## Product Change Notice (PCN)

PCN Number: **PCN-0451151R-01**

Product(s) Affected: PJ-037BH

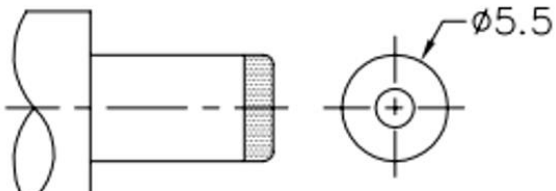
Description of Change: mechanical differences as shown below:

MATERIAL	PLATING
center pin	copper	nickel
terminal 1	brass	silver
terminal 2	copper alloy	silver
plastic	PBT

DESCRIPTION	MATERIAL	PLATING/COLOR
center pin	copper alloy	nickel
terminal 1	brass t=0.3 mm	nickel-silver
terminal 2	phosphor bronze t=0.3 mm	nickel-silver
housing	PBT (UL94V-0)	black
cover	PBT (UL94V-0)	black

**MATING PLUG**  
Jack Insertion Depth: 9.0 mm

**MATING PLUG**  
Jack Insertion Depth: 9.8 mm

Insertion/extraction force adjusted to 0.3 ~ 2.0 kg
